**Request for Additional Information No. 163 (1809, 1763), Supplement 3, Revision 0**

**U. S. EPR Standard Design Certification**

**Docket No. 52-020**

**SRP Section: 09.03.03 - Equipment and Floor Drainage System**

Figure 9.3.3-1—Nuclear Island Drain and Vent System  
Sheet 2 of 8

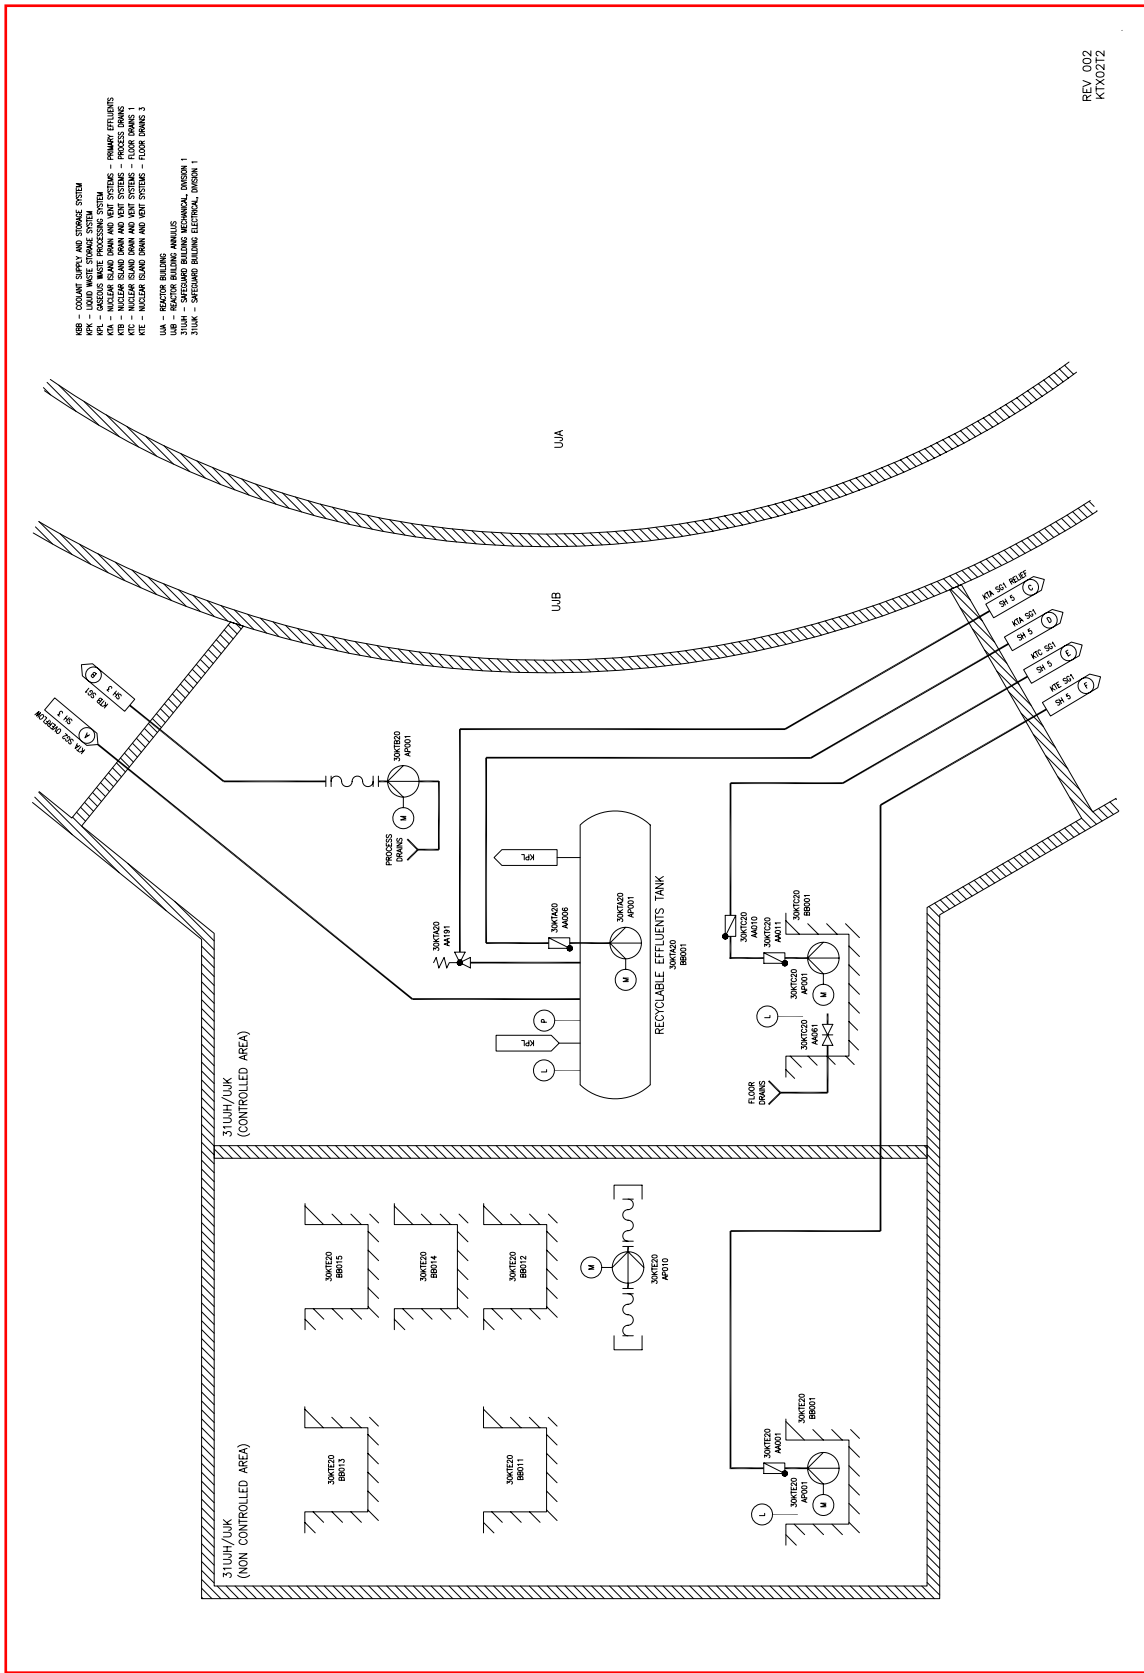
GDC 4 requires safety-related components to be protected against environmental conditions such as flooding. The staff reviewed the NIDVS check valves that prevent backflow of flooding water through the drain system into areas of the plant containing safety-related equipment. NIDVS piping between the two divisions of the fuel building (FB) and between safeguard buildings SB-1, SB-2, SB-3, and SB-4 rely upon double check valves to prevent back flow. The NIDVS piping in the nuclear auxiliary building (NAB) connects to safety-related equipment areas of the FB and SB. Following the review procedures described in SRP Section 9.3.3 Subsection III.1, and RG 1.29, Regulatory Position C.2, the staff found that failure of these nonsafety-related piping and check valves could affect the flood protection of safety-related SSCs. Therefore, the safety significance of these piping and check valves may justify increased attention to their reliability and ability to function following a seismic event.

Discuss the ability of these nonsafety-related piping and check valves to function following a seismic event, and the requirements of testing and inspection of these components to ensure the reliability of these components to be able to perform their intended function.

Pump discharge lines from the nuclear island drain/vent system (NIDVS) in each of the Safeguard Buildings (SB), as well as the sumps from the Fuel Building (FB), are individually routed to their destination in the Nuclear Auxiliary Building (NAB). As a result, failure of a check valve in any of these discharge lines does not provide an opportunity for backflow from one sump discharge into another.

The collection tank in the NAB has separate nozzles for each incoming line, and an air gap provides further protection against backflow to the sumps.

U.S. EPR FSAR, Tier 2, Section 9.3.3.2.3 will be revised to state that sump pump discharge lines in each of the SB and FB are routed individually to their destination. U.S. EPR FSAR, Tier 2, Figure 9.3.3-1—Nuclear Island Drain and Vent System, Sheets 2 through 8 will be revised to show this piping layout.
